North Fork American River Shaded Fuelbreak Phase III Pre-proposal Field Tour Questions and Answers

South Treatments

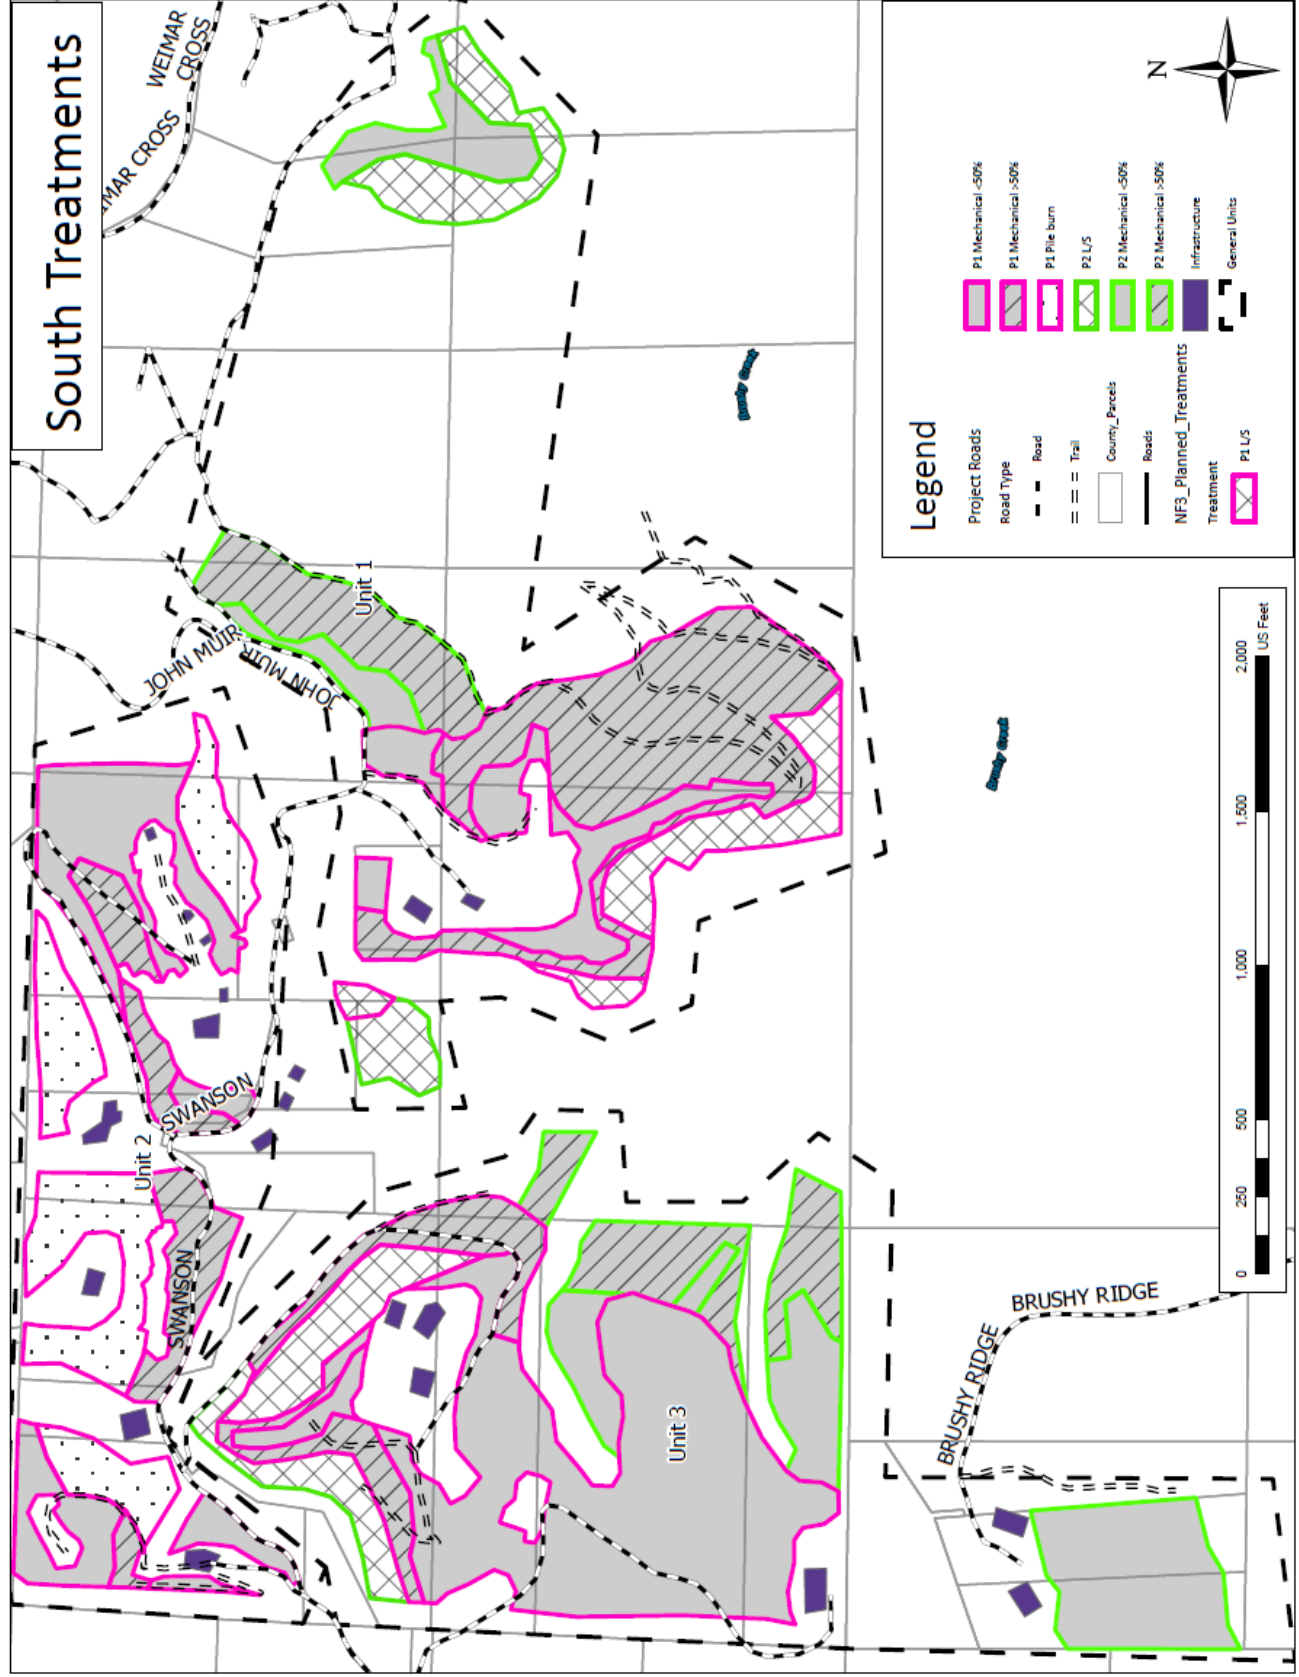
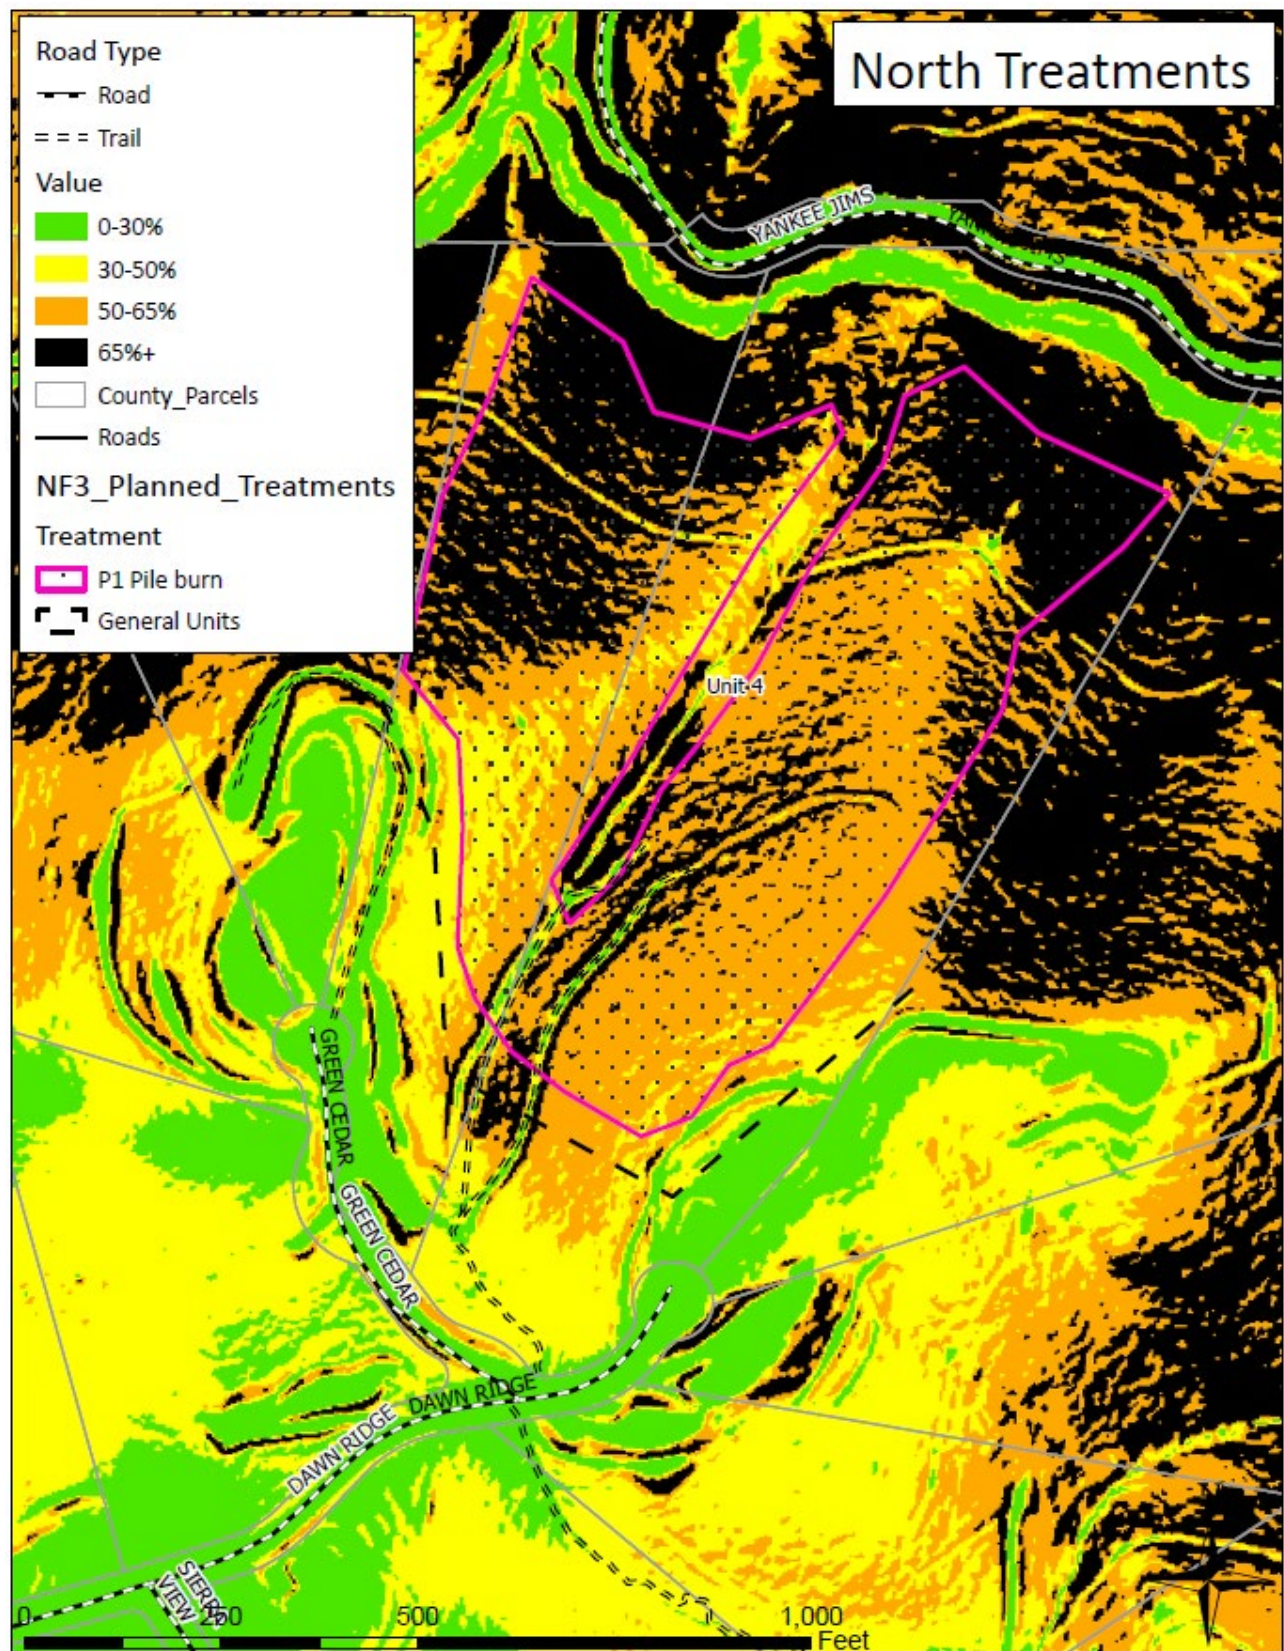
- Q: Can slope map include different treatment types?
 - A: See attached map at end of this document
- Q: Can you cut larger than 6in oaks to gain access into units?

- A: Stems smaller than 6” in a clump and dead stems up to 14” shall be cut to meet spacing requirements. Live stems larger than 6” shall not be cut.
- Q: Can the Placer RCD provide unit numbers for referencing in the bids?

- A: Attached map includes polygons for houses. Wells, low powerlines, and other small infrastructure will be included on operations maps after contract is awarded.

- A: Attached map shows the project area broken into 4 general units
- Q: Is there an earlier deadline for pile burning?
 - A: No
- Q: Will RCD assist with pile burning?
